Independent Pricing and Regulatory  
Tribunal (IPART)

# Austral & Leppington North Draft Contributions Plan

Review of Stormwater Works - Nexus and  
Costs

**FINAL REPORT**

Plate 3-1 - Raingarden General Arrangement at Intersection (SMEC 2021)

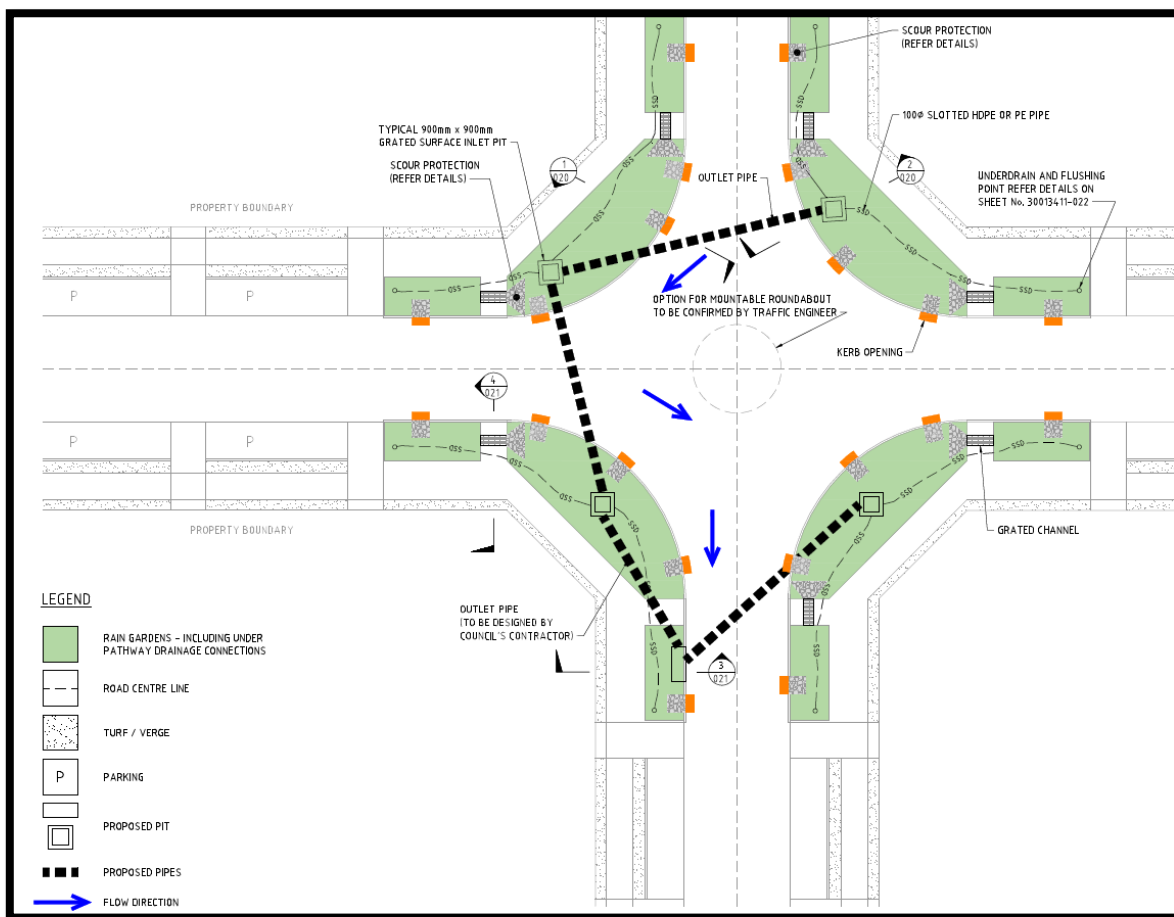
the cost review is aligned with the SMEC concept design for a 4-way intersection (refer to Plate 3-1) Cost rates were reviewed and adjusted where there was a significant rate difference identified. Some additional work components were added where this was deemed appropriate to fully define likely costs or to reflect the raingardens construction delivery staging.

Item	SMEC total direct cost estimate	JWP total direct and indirect cost estimate	Indicative cost change	Indicative cost change %
4-way intersection	\$116,471	\$298,580	\$182,109	256%

When the project on-costs are included, the cost is \$343,366 which equates to \$1,196/sqm. This rate is consistent with the expected costs for these elements specified by Melbourne Water and more broadly across the Stormwater industry (see further discussion in Section 4.3.4).

Plate 6-1 – Case Study Catchment Drainage System NB11\_P4\_01 (SMEC 2021)

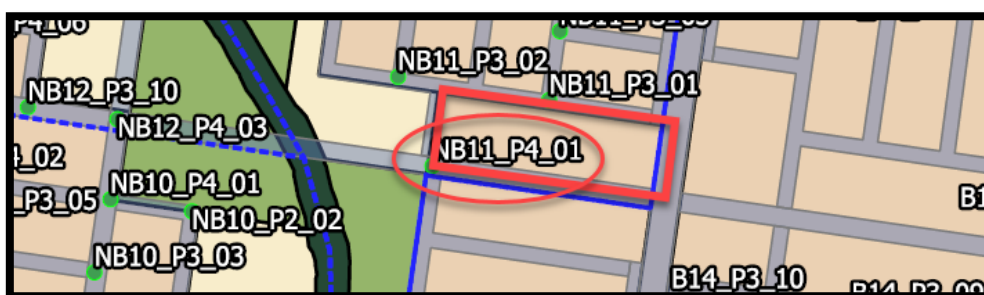
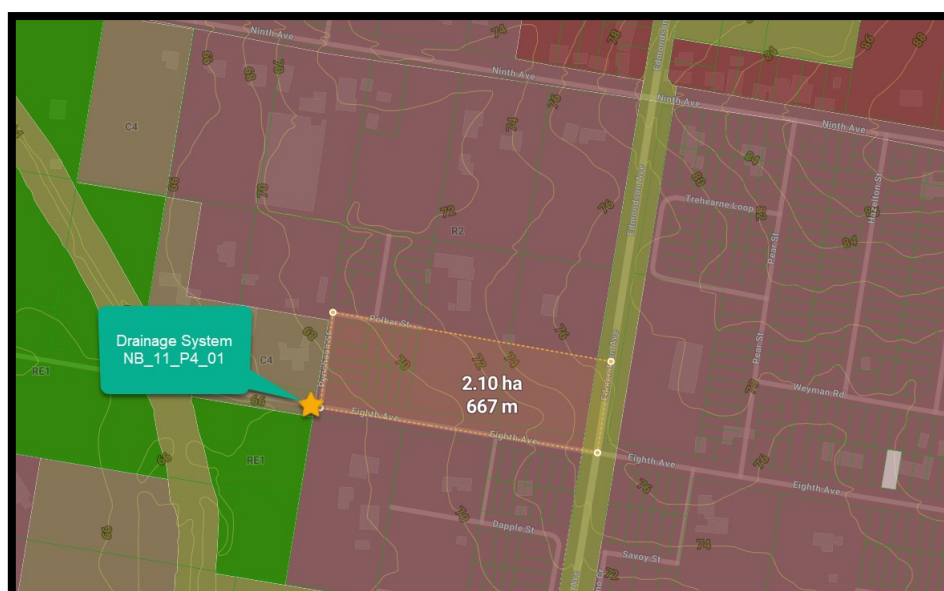
As a case study, we have considered an example catchment from the Streetscape Masterplan (SMEC, 2021) which drains to the corner of Eighth Avenue and Pyncheon Street in Austral. The catchment has an area of approximately 2.1 ha and is bound by Polbar Street to the north, Eighth Avenue to the south, Pyncheon Street to the West and Edmondson Avenue to the east. Plate 5-1 below provides an overview of the location as shown in the Masterplan, and Plate 5-2 provides an overview of the catchment extent, elevation contours, and current land zoning.

Liverpool City Council's engineering guideline requires a maximum gutter flow width in the roads of 2.5 m in the 20% AEP (5-year ARI) storm event, and for the velocity x depth product to be less than 0.4 m<sup>2</sup>/s in a 1% AEP (100-year ARI) storm event which is a measurement indicative of pedestrian and vehicle safety. An assessment for a typical 9 m wide carriageway was undertaken. Details are provided in Table 6-1 below.
